Woodridge ES
Change Order - Breakdown

RE: Woodridge Elementary School Major Building System Replacement
IOC #004 – Addendum #001, Dated 05/23/23

Project Name: Woodridge Elementary School Major Building System Replacement
Location: 4120 Cedar Ridge Trail. Stone Mountain, GA 30083
Architect: Cooper Carry
Description of Change: ADDENDUM #001, DATED 05/23/23

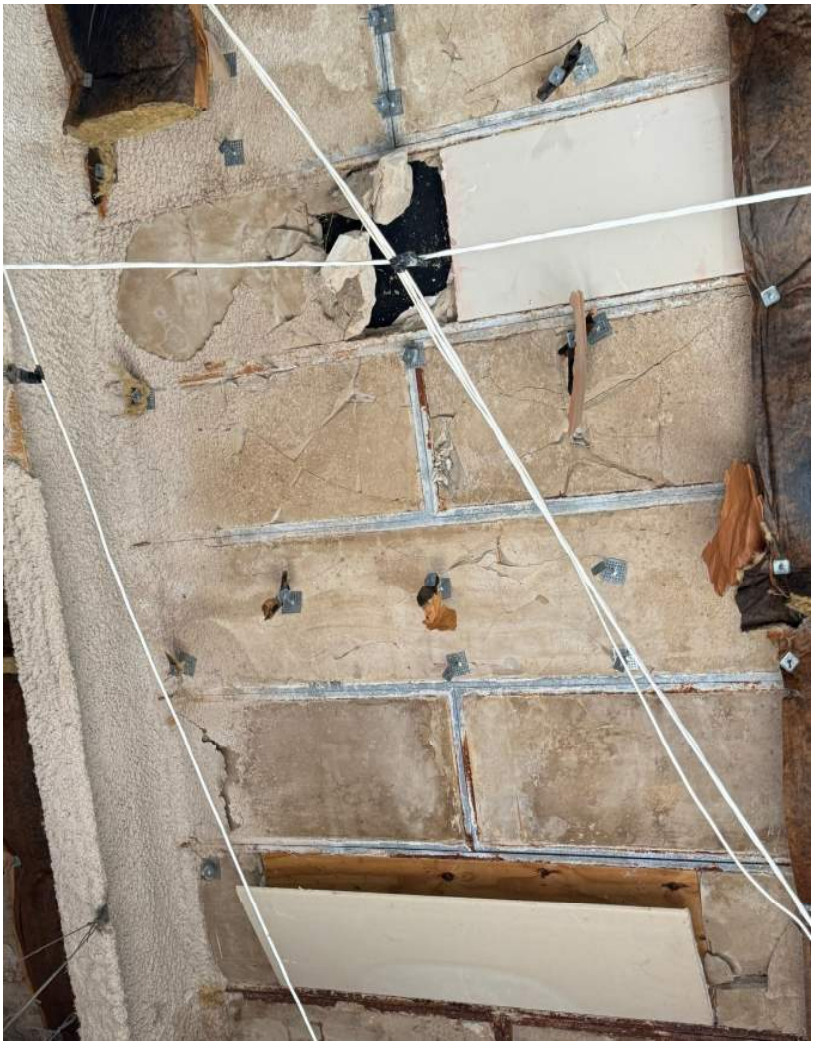
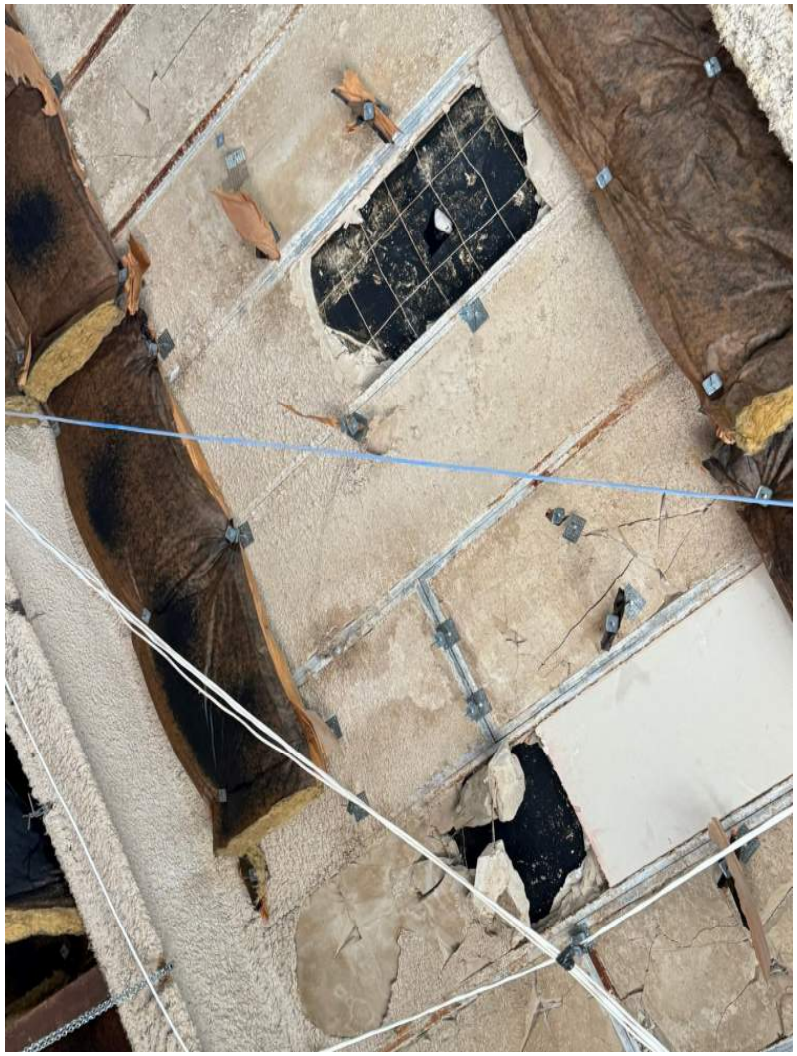
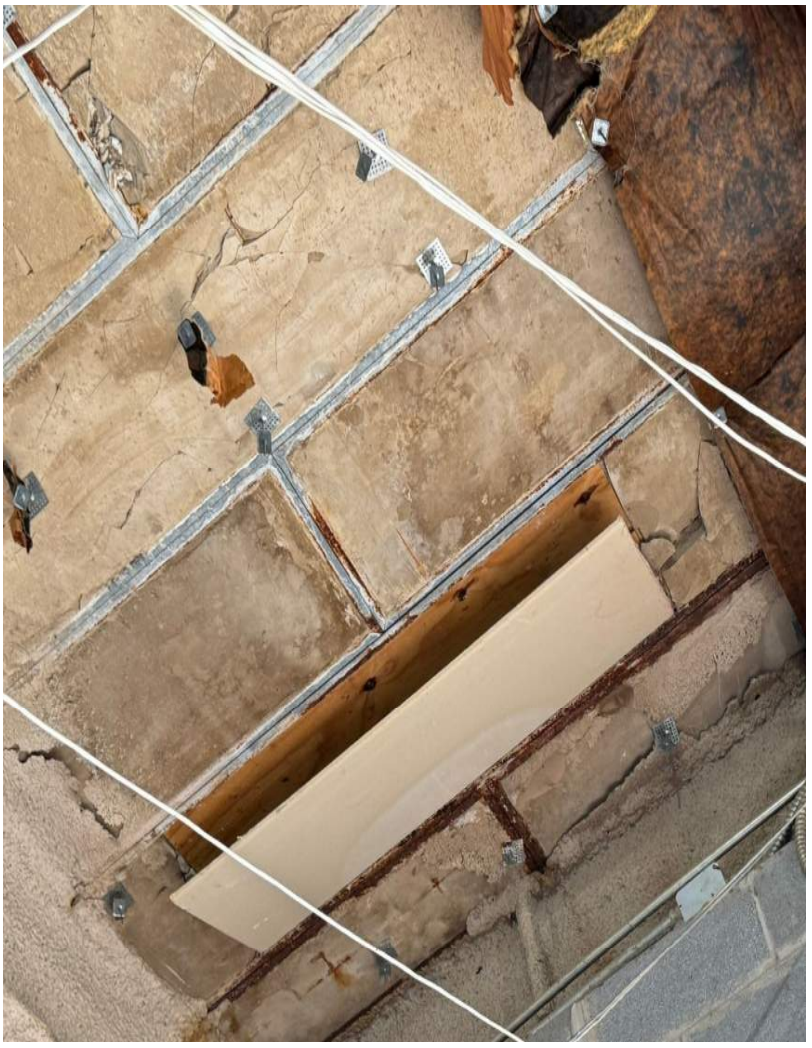
Description:
The current roof decking above the cafeteria is failing in various areas, please see the attached images for more detail. The roofer is testing the structure to help advise what it should be replaced with. Please confirm that the decking needs to be replaced and provide details for the new decking over the cafeteria.

Question:
Please confirm the decking needs to be replaced. Please provide details for the new decking over the cafeteria.

1 / A11.11 REFLECTED CEILING PLAN - AREA A
SCALE: 3/32" = 1'-0"

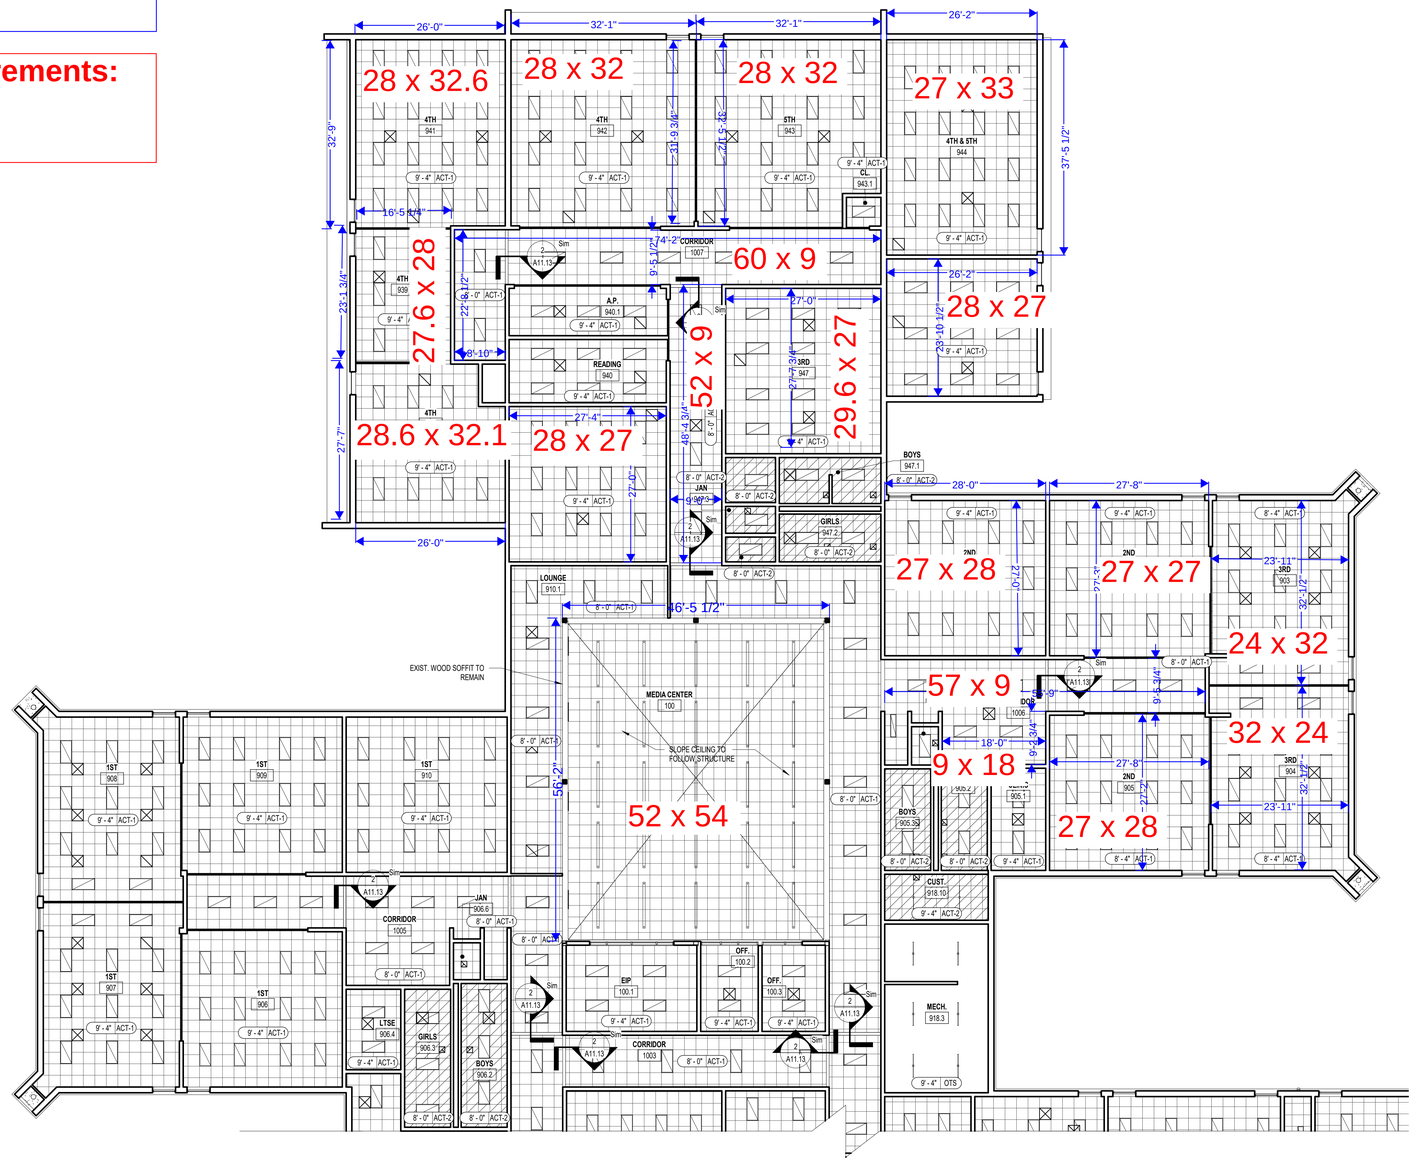
Attached, please find our proposal to furnish and install the additional ceiling grid and tiles needed based on the actual field verified square footage (see attached markup). The RCP plan (A11.11) identified some discrepancies of the overall room square footage based on actual field conditions. The attached markup explains the discrepancies. Please note that the only costs associated with this discrepancy were ceiling gird and tiles. The design team confirmed that no additional life safety devices needed to be added.

1 / A11.10 OVERALL REFLECTED CEILING PLAN
SCALE: 1/16" = 1'-0"

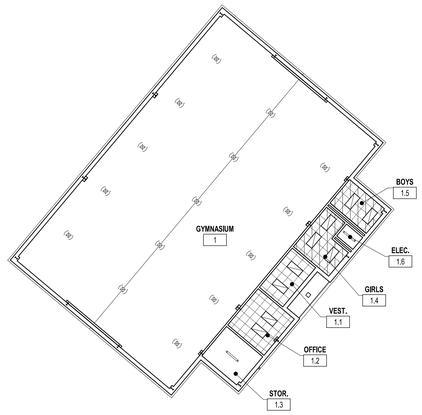
Description:
Sheet A11.10 calls for 2 x 4 light fixtures in the small rooms in rooms 947.1 and 947.2, please see the attached markup for reference. These rooms are drawn longer than they actually are and a 2 x 4 fixture will not fit in there. A 2 x 2 fixture is required for these rooms. The janitor's closet is excluded from this. We were able to turn the 2 x 4 fixture and make it work in that room.

5 New Water Entry Part Plan - Gym

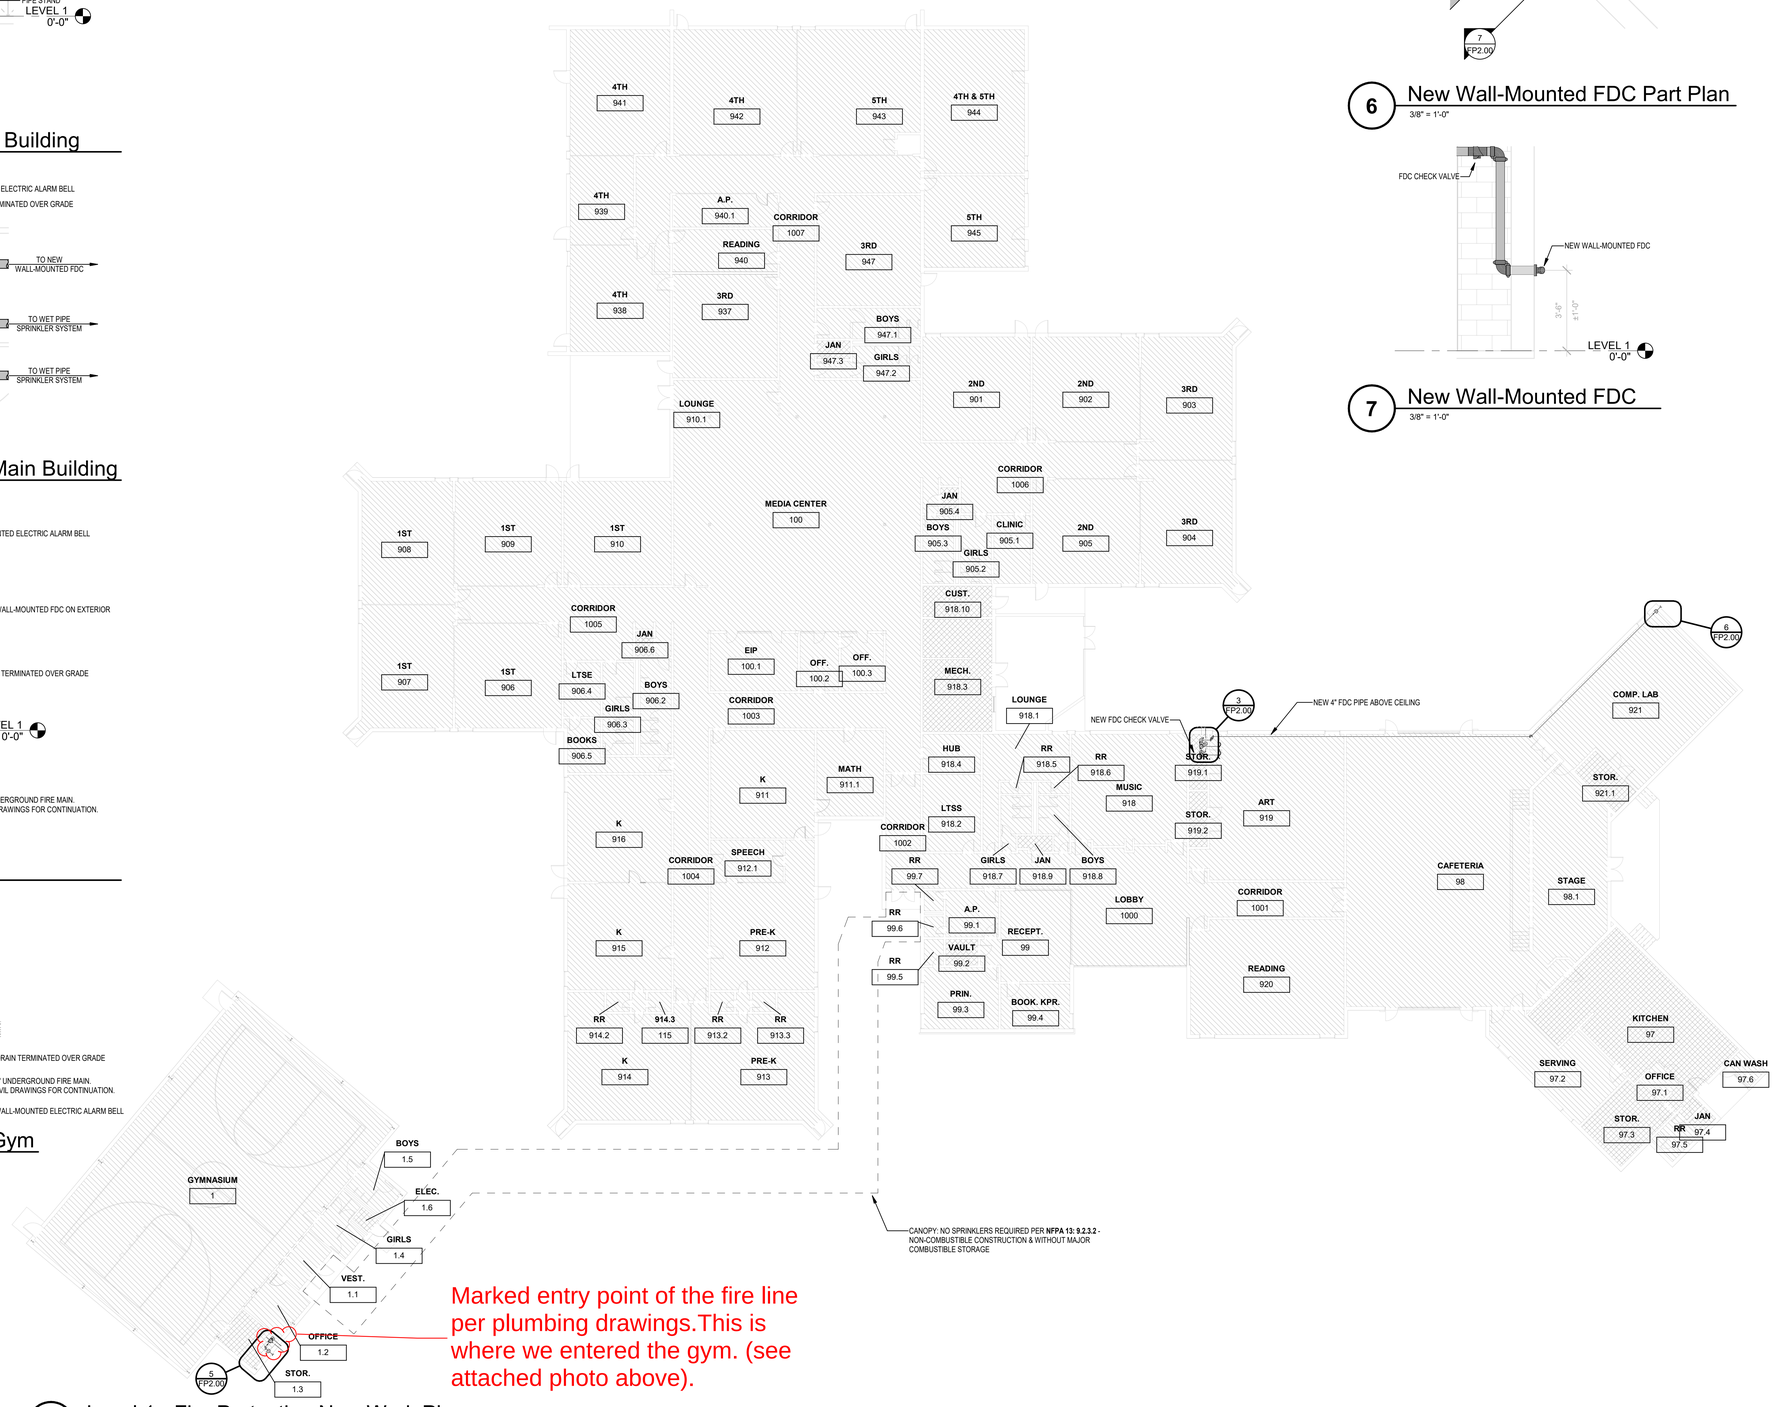
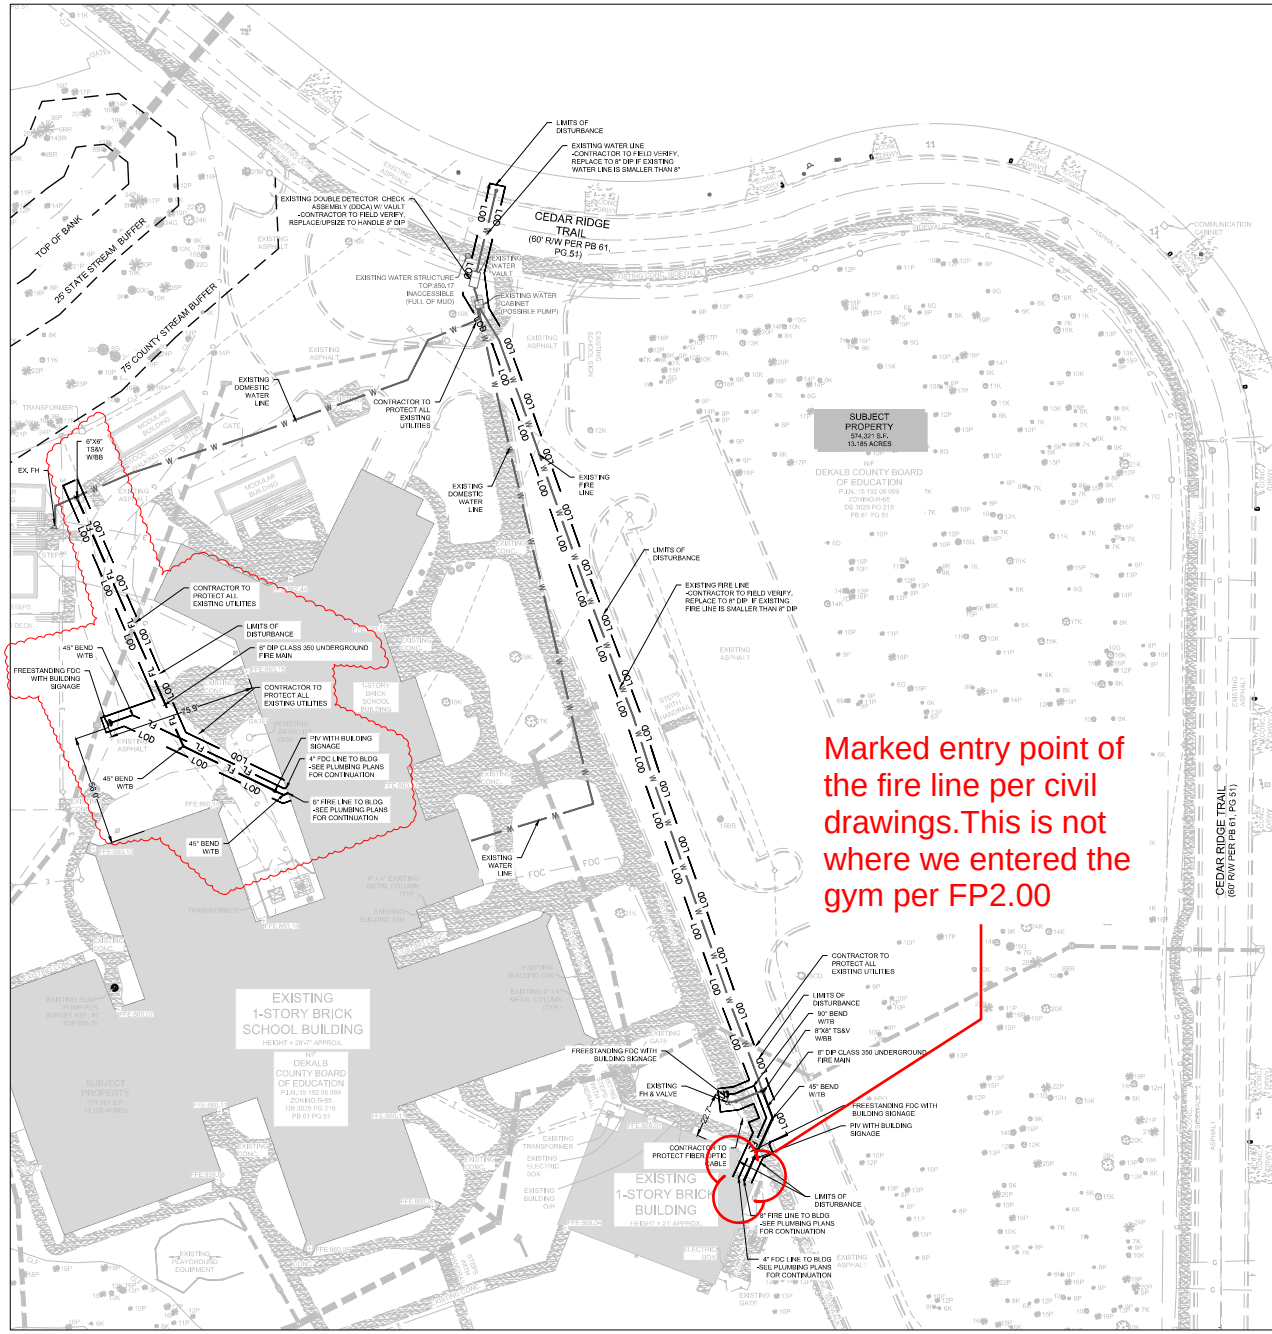
Description: It was discovered that the fire line is noted to enter the gym at two different walls on drawings C5.0 and FP2.00. Please see the attached markups of drawings C5.0 and FP2.00 that note the two differing entry points. The fire line will need to enter the gym through the wall specified on drawing FP2.00. Please confirm the fire line will enter the gym through the wall specified on drawing FP2.00 and not the wall specified on drawing C5.0.

Question: Confirm the fire line will enter the gym through the wall specified on drawing FP2.00 and not the wall specified on drawing C5.0.

The fire sprinkler riser is to be located in the storage room as shown in the plumbing plans, sheet FP2.00.
